## **Proposal for amendments to ECE/TRANS/WP.29/GRSP/2012/21**

### **Proposal for Supplement 7 to the 04 series of amendments**

The text reproduced below was prepared by the expert from the France on behalf of the Technical Services Group (TSG) on UN Regulation No. 44. It aims to clarify the lap strap interaction with the dummy and its assessment as well as improving the overturning test procedure in light of recent findings. The modifications to the current text of the UN Regulation are marked in bold for new or strikethrough for deleted characters.

### Load application device I (to be used for Group 0 / 0+ products)

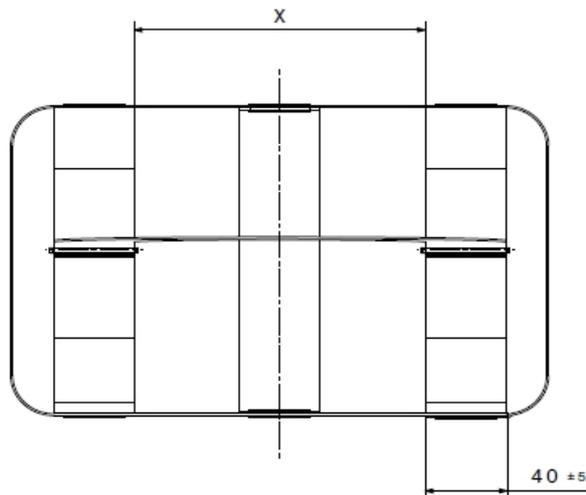
*Insert a new Annex 23, to read:*

No.	Name	Information	Quantity
1	head belt - 39mm	-	1
2	shoulder belt lh/rh - 39mm	-	2
3	crotch belt - 39mm	-	1
4	hip belt - 39mm	-	1
5	stitch pattern (30x17)	stich: 77, thread: 30	8
6	plastic buckle	-	2
7	stitch pattern (2x37)	stich: 77, thread: 30	2

stretch lenght	(+/-5mm)					
	Dummy P/Q 0	Dummy P/3/4	P/Q 1,5	P/Q 3	P/Q 6	P/Q 10
head belt	1000mm	1000mm	1000mm	1200mm	1200mm	1200mm
shoulder belt	750mm	850mm	950mm	1000mm	1100mm	1300mm
crotch belt	300mm	350mm	400mm	400mm	450mm	570mm
hip belt	400mm	500mm	550mm	600mm	700mm	800mm
dimension X	120mm	130mm	140mm	140mm	150mm	160mm

stich pattern	min. required force
12x12mm	3,5 kN
30x12mm	5,3 kN
30x17mm	5,3 kN
30x30mm	7,0 kN

## Load application device II (to be used for Group 1)

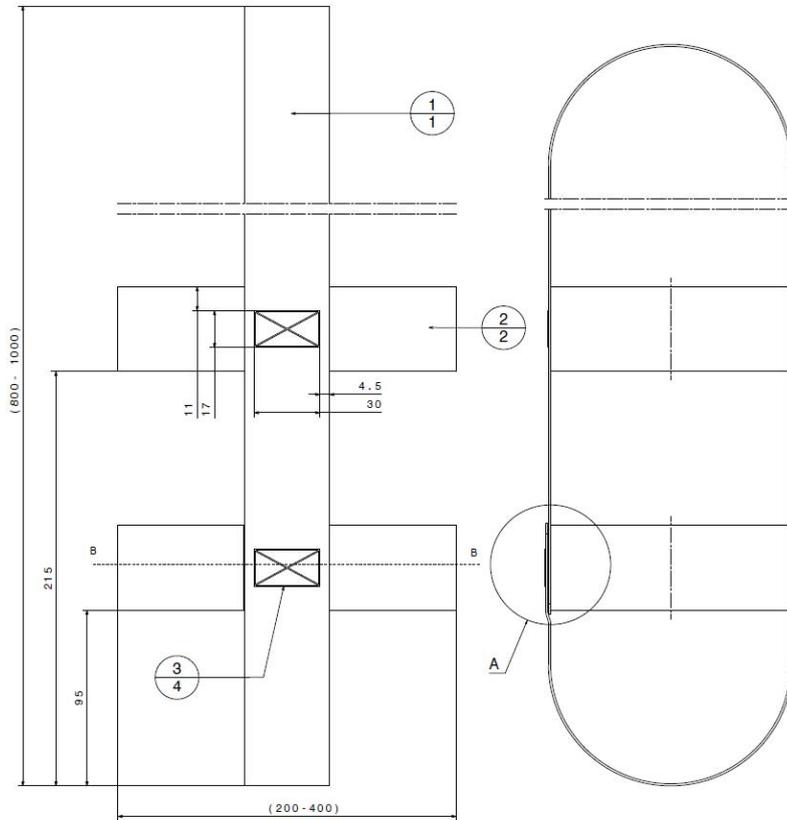
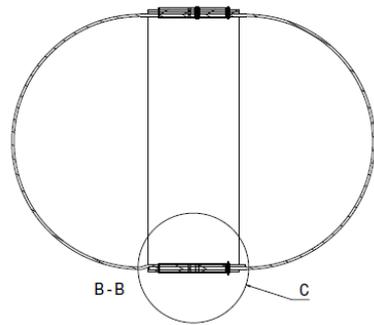
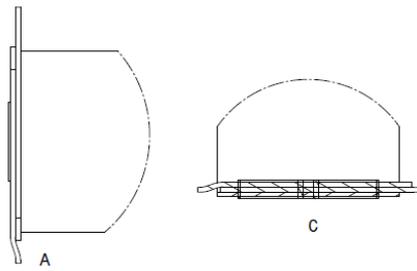
No.	Name	Information	Quantity
1	main belt - 39mm	-	1
2	hip belt (upper/lower) - 39mm	-	2
3	stitch pattern (30x17)	stich: 77, thread: 30	4

stretch length	(+/-5mm)					
	Dummy P/Q 0	Dummy P/S/4	P/Q 1,5	P/Q 3	P/Q 6	P/Q 10
main belt	1600mm	1600mm	1600mm	2000mm	2000mm	2000mm
hip belt	440mm	540	640mm	740mm	740mm	840mm

stich pattern	min. required force
12x12mm	3,5 kN
30x12mm	5,3 kN
30x17mm	5,3 kN
30x30mm	7,0 kN
